(1) HGB 2015 Ozone NAAQS Moderate AD SIP Revision, Non-Rule Project No. 2022-022-SIP-NR, Docket No. 2023-0306-SIP;

(2) DFW 2015 Ozone NAAQS Moderate AD SIP Revision, Non-Rule Project No. 2022-021-SIP-NR, Docket No. 2023-0305-SIP; and

(3) Bexar County 2015 Ozone NAAQS Moderate AD SIP Revision Non-Rule Project No. 2022-025-SIP-NR. Docket No. 2023-0319-SIP

RE: Sierra Club Comments on Commission Approval for Proposal of the Houston-Galveston-Brazoria (“HGB”), Dallas Fort-Worth (“DFW”), and Bexar County Moderate Area Attainment Demonstration (“AD”) State Implementation Plan (“SIP”) Revisions for the 2015 Eight-Hour Ozone National Ambient Air Quality Standard (“NAAQS”)

Figure 3. Facility locations with AQS ozone monitoring stations that exceeded that NAAQS and EJ zip codes located in 2015 ozone moderate nonattainment areas.

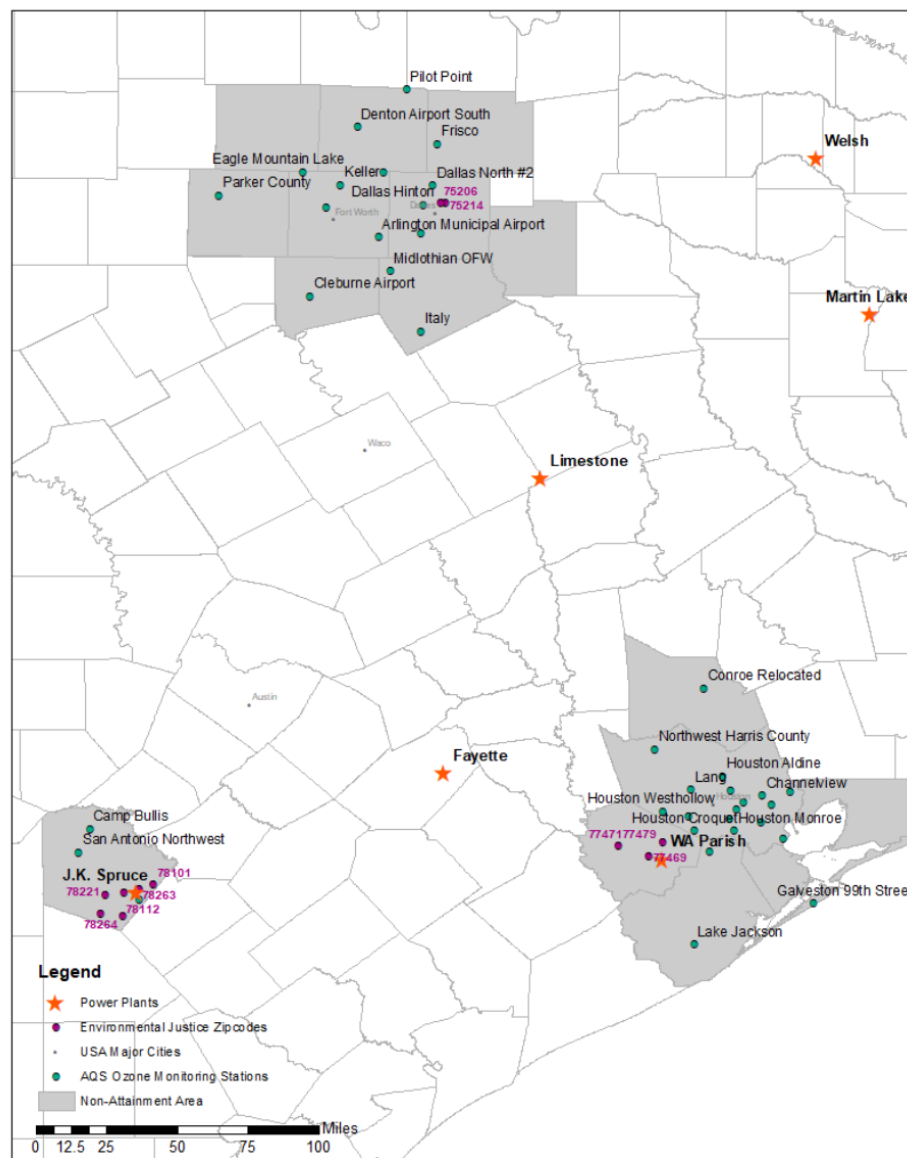
As the map in Figure 3 of the Sonoma Report makes clear, the monitors are not well located to record ozone levels in those communities. For example, some of the environmental justice ZIP Codes Sonoma modeled were located in the nonattainment area between the WA Parish plant and the nearest AQS monitors,

which were farther away. As Sonoma Report Table 13 included above demonstrates, the WA Parish plant's impacts exceed 0.5% of the NAAQS in the environmental justice communities that were modeled by Sonoma on almost every day that the ozone monitors in the Houston-Galveston-Brazoria registered an ozone nonattainment day.⁵⁷

Figure 1: Long term DFW 8-hour monitoring trends

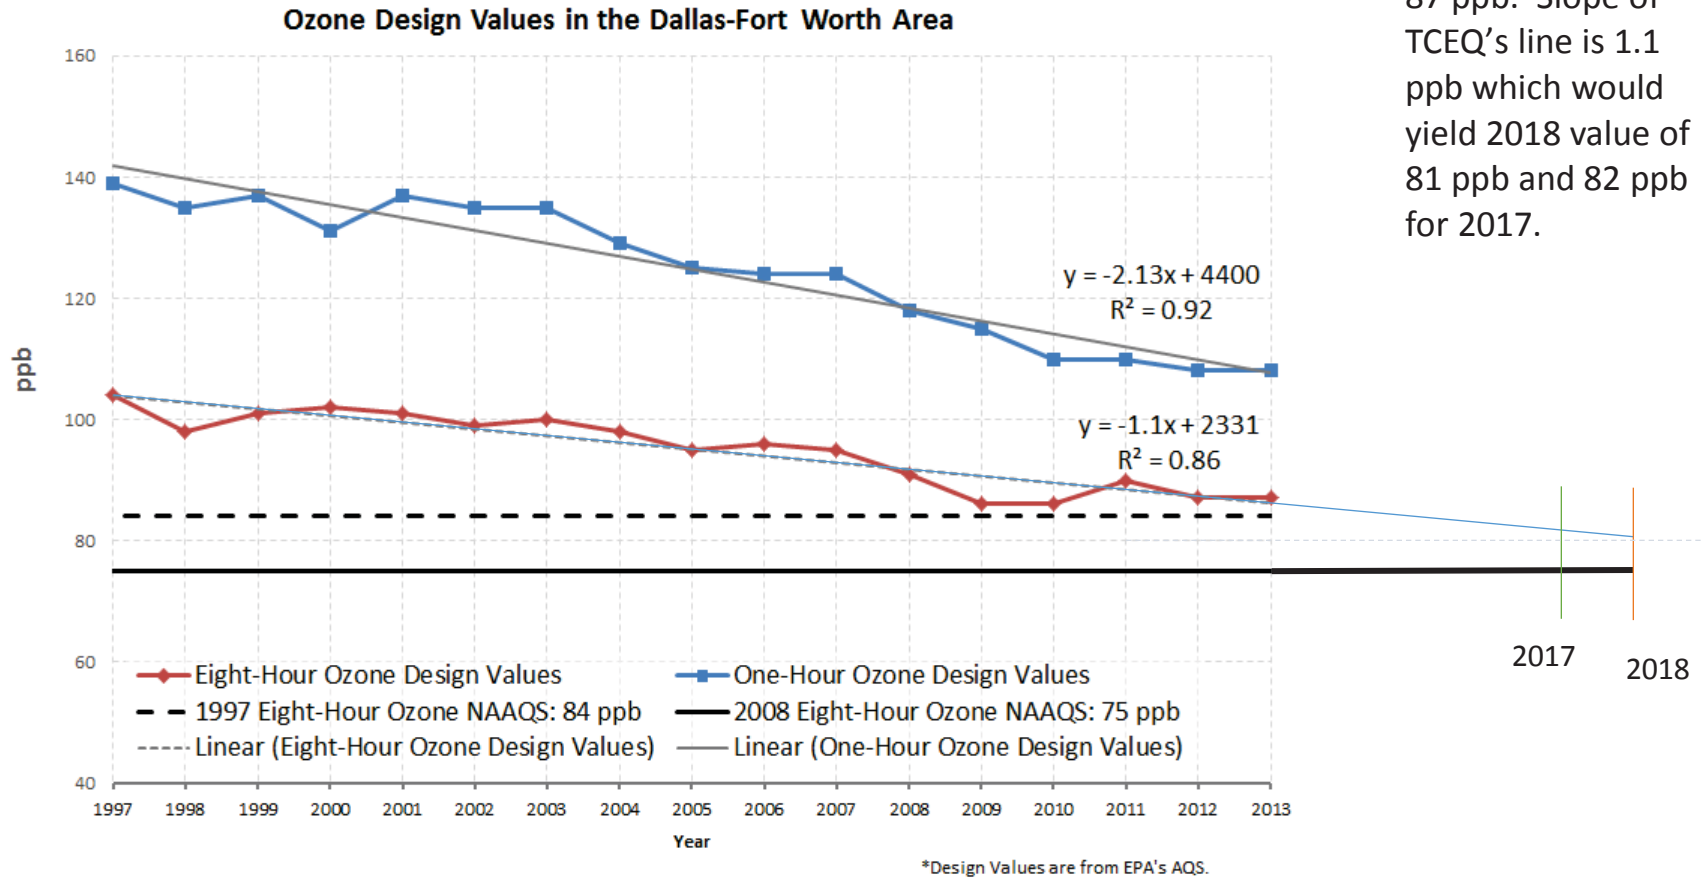
We note that normal on-road/non-road fleet turnover within areas of DFW and Texas will help lower ozone levels in the DFW area. In TCEQ's SIP proposal, TCEQ provides a long term trends analysis that also included a linear relationship to estimate the long term ozone level change. This equation indicates the 8-hour values have dropped at a rate of 1.1 ppb per year. We modified the table to extrapolate the DFW 8-hour ozone DVs in 2017 and 2018, which were still 80-82 ppb for these future years based on this rate of reduction. See Figure 1 on page 7. Since the overwhelming majority of reductions of NO_x in the plan are the federal measures for on road and off road sources, it seems unreasonable to expect this rate of reduction to accelerate. Based on the monitoring data and lack of additional large reductions in NO_x within areas of Texas that impact DFW, it is difficult to see how the area would reach attainment in 2018 based solely on federal measures reductions from mobile and non-road. The fact that the attainment year will likely be 2017 makes the chance of attainment smaller.
